# Wire Harness Replacement Kit

Models: Tennant T7 / Nobles Speed Scrub Rider

This kit includes the necessary parts to replace a defective main wire harness on a T7/Speed Scrub Rider. Kit installation is required by TennantTrue® service or an authorized Tennant service provider.

Controller Board

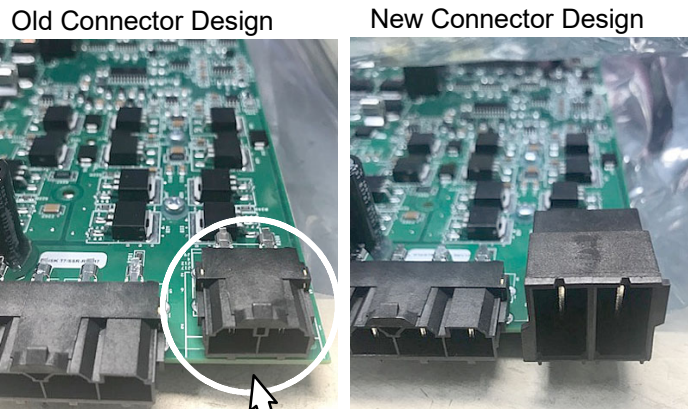
**INSTALLATION NOTICE:** For machines equipped with an old controller board design, shown below, install the supplied connector adapter (p/n 1076631) as described below. The new wire harness is equipped with an upgraded connector design to accommodate the latest controller board design.

\* If the controller board is equipped with the old connector design, shown below, the new wire harness must be reworked with the supplied connector adapter as described in the following instructions.

Connector Adapter Required

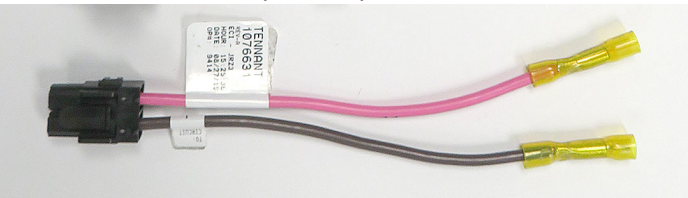
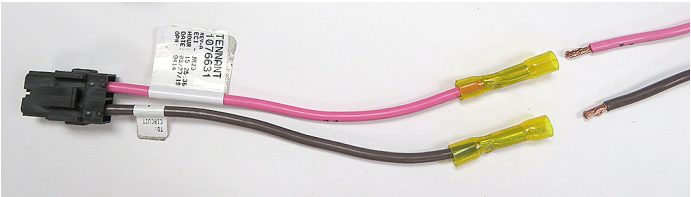
Cut and strip the brown/12 & pink/11 wires. Strip wires 3/8" (9.5 mm)

Connect the supplied harness connector adapter using an insulated terminal crimping tool. Seal the terminal connectors with a heat gun.
